**UNITED STATES
NUCLEAR REGULATORY COMMISSION**
WASHINGTON, D.C. 20555-0001

**SUBJECT: OREGON STATE UNIVERSITY – ISSUANCE OF AMENDMENT NO. 26 TO
RENEWED FACILITY OPERATING LICENSE NO. R-106 FOR THE OREGON
STATE TRIGA REACTOR (EPID NO. L-2020-NFA-0005)**

This amendment revises OSU License Condition 2.C.(1) from a temperature limit to a reactivity limit, and revises various OSU TSs to remove the requirements related to the fuel temperature measurement obtained from the licensee's instrumented fuel element (IFE). This amendment also reverses a limitation imposed in License Amendment No. 25 (ADAMS Accession Package No. ML19011A340), that prohibited transient mode operation (i.e., pulse and square-wave) without an IFE. Additionally, this amendment implements numerous grammatical and format changes to improve the clarity and readability of the TSs.

Figure 1 - Administrative Structure

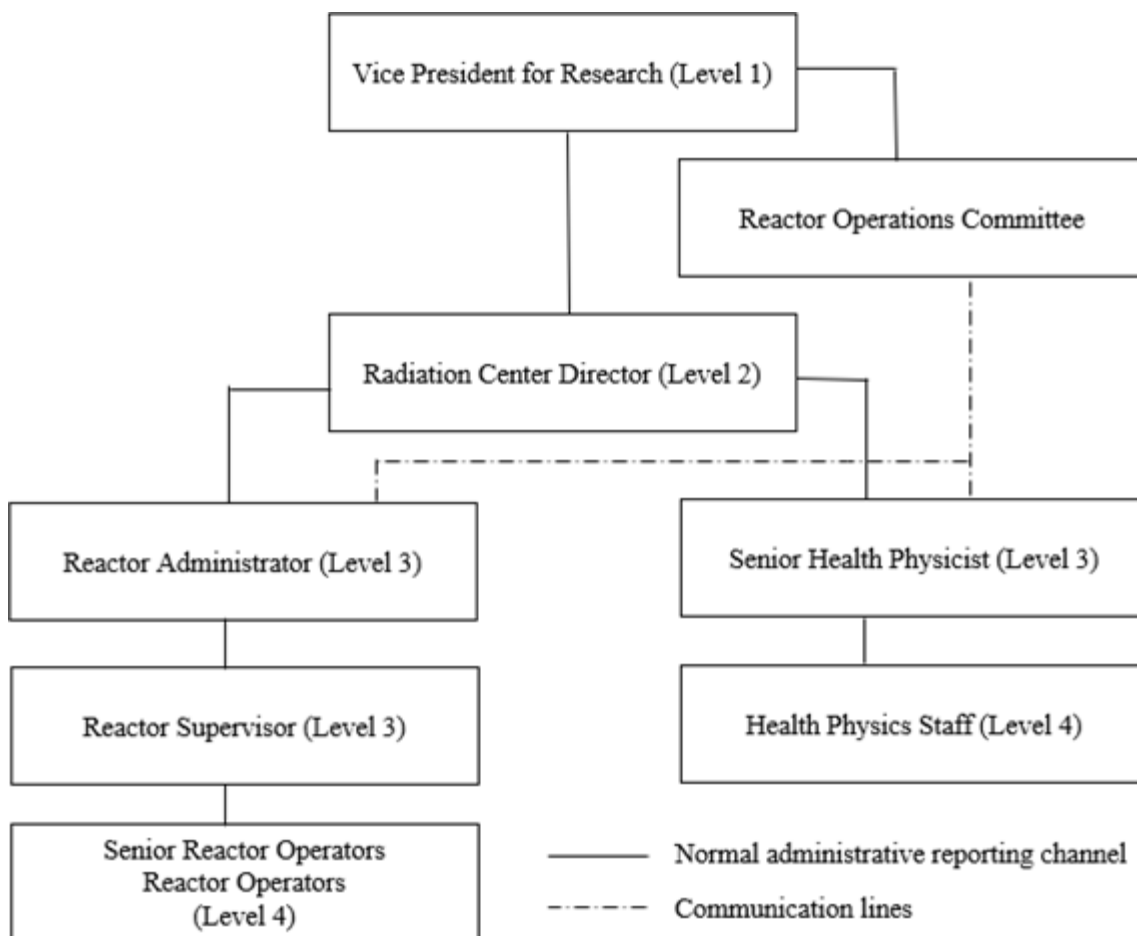
The licensee proposes to add “Senior Reactor Operators” as Level 4 operating staff in TS 6.1.2, Figure 1, “Administrative Structure,” to correct an inconsistency with TS 6.1.2.f that includes senior reactor operators as Level 4 operating staff.

The NRC staff evaluated the changes to TS 6.1.2, Figure 1 using the guidance in ANSI/ANS-15.1-2007, Section 6.1.1 that describes the Level 4 organization as the operating staff, such as senior reactor operators and reactor operators. The NRC staff finds that adding “Senior Reactor Operators” to the Level 4 organizational structure organizational structure in TS 6.1.2, Figure 1 is consistent with the guidance because Level 4 accurately describes the operating staff, the reporting lines of the Level 4 are unchanged, and senior reactor operators’ activities would continue to report to the reactor supervisor (Level 3). Because the changes to TS 6.1.2, Figure 1 are consistent with guidance and provide administrative controls relating to
